Cross River Rail project

Coordinator-General's change report – no. 10

June 2021

Figure 4.2 Existing approved Albert Street Station worksite haulage route

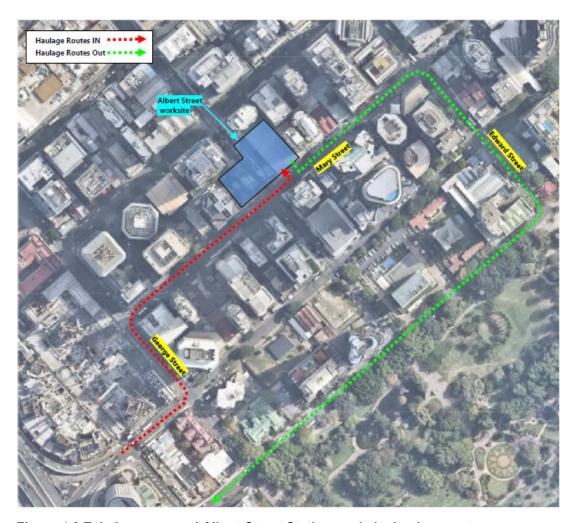
The application for project change states that up to 10 heavy vehicles per hour (vph) would haul spoil from each of the worksites on Sunday (10 vph into each site and 10 vph out of each site). In total, a maximum of 95 heavy vehicle movements would occur at each worksite during the 9.5-hour period proposed. Both haul routes operate in a single one-way loop, which means that the routes into the worksites are different to the way out (see Figures 4.1 and 4.2).

The request for project change is not seeking to change the access of the approved haulage routes. Rather the request seeks to alter the times that they operate, with haulage proposed on Sunday between 9:00am – 6:30pm.
